From: Dave Lochbaum [DLochbaum@ucsusa.org]
Sent: Tuesday, July 07, 2015 9:15 AM
To: Dean, Bill
Cc: Dapas, Marc; Markley, Michael; Lyon, Fred
Subject: [External_Sender] Flood protection at Fort Calhoun
Attachments: 20150707-fc-ucs-nrc-intake-amendment.pdf

SUBJECT: Fort Calhoun's Revised Flood Protection Standards

The Nuclear Regulatory Commission (NRC) issued Amendment No. 282 to the operating license for the Fort Calhoun Station (ML15111A399) on June 30, 2015. Mr. Richard Andrews emailed the amendment to me along with safety concerns he had about it. After reviewing the amendment including its safety evaluation, the original amendment request (ML13231A178), and associated responses to requests for additional information (ML14226A738, ML15050A246, and ML15083A359) sent to the licensee by the NRC during its review, I was unable to resolve either of Mr. Andrews's concerns. The NRC staff may have considered both concerns during its deliberations, but it is not apparent from the available documents that the concerns were evaluated and found to have been addressed. With Mr. Andrews's knowledge and consent, I am communicating the concerns to you with a request for a written response wit

Cross-section of the Intake Structure Pump House at Fort Calhoun

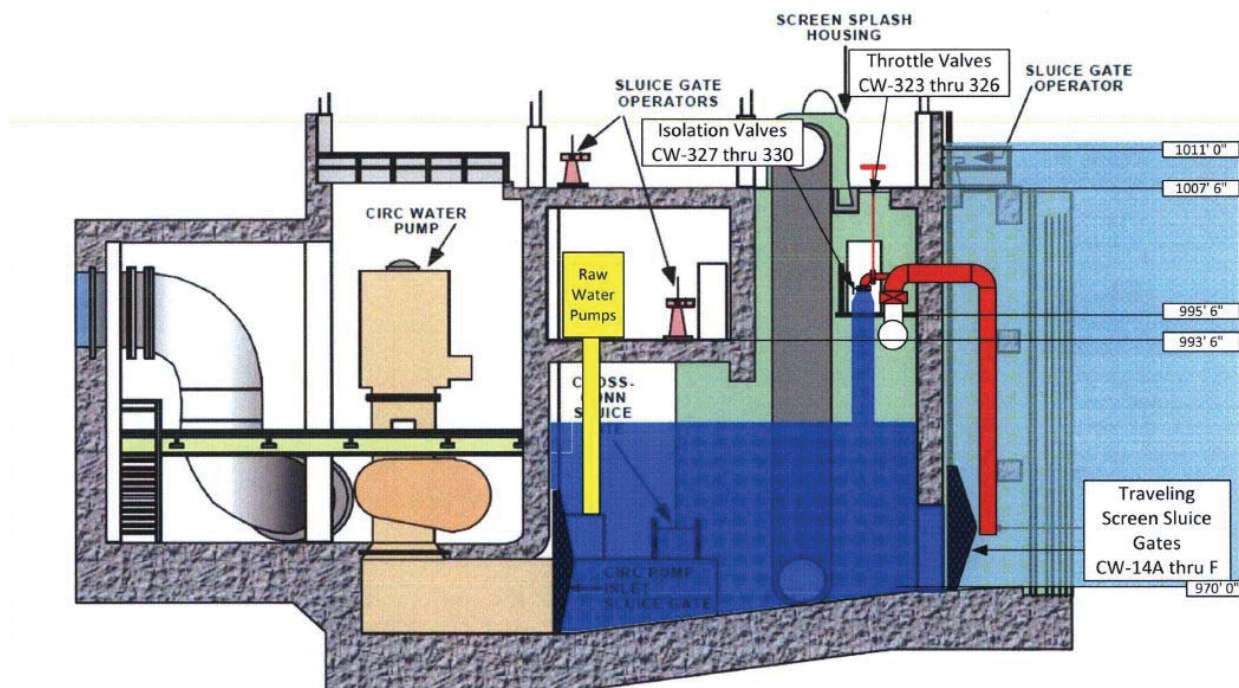
The revised flood protection scheme at Fort Calhoun does not seem to be designed against an assumed single failure.

In the revised design, all six traveling screen sluice gates must be closed to assure adequate flood protection. A single failure can prevent one sluice gate from closing. The inability to adequately control the water level in the raw water pump pit could result in the electric motors and/or controls for the pumps

Neither the licensee nor the NRC addressed how the single failure requirement was met by the revised design or explained why this longstanding safety requirement is now not applicable.

The 'sufficient time for needed repairs' argument made by the owner in this case is not used for safety components like the emergency diesel generators (EDGs). The safety systems powered from the EDGs have mission times lasting up to 30 days following an accident. To comply with Appendix A to 10 CFR Part 50 and its single failure provisions, designs feature diverse, redundant components. The single failure requirement is NOT satisfied by fixing something that has broken or malfunctioned.

But what about the traveling screen sluice gates? It's not clear that they are seismically qualified. It appears that the owner applied the same logic to the sluice gates' qualification as it applied—without success—to the new valves and piping.

It's not a stretch to postulate that a seismic event could damage the mechanism used to raise and lower one or more sluice gates since none is seismically qualified. (If all were seismically qualified, it would not be a stretch to postulate that one, per the aforementioned single failure provision, mechanism is damaged. Absent seismic qualification, the single failure provision does nothing to limit the damage to just one sluice gate and all six could be impaired by a seismic event.

The NRC staff required the owner to seismically qualify the four new valves and associated piping because a flooding event could follow a seismic event. Likewise, it follows that the NRC must also require that the sluice gates and their associated movement and control devices be seismically qualified.
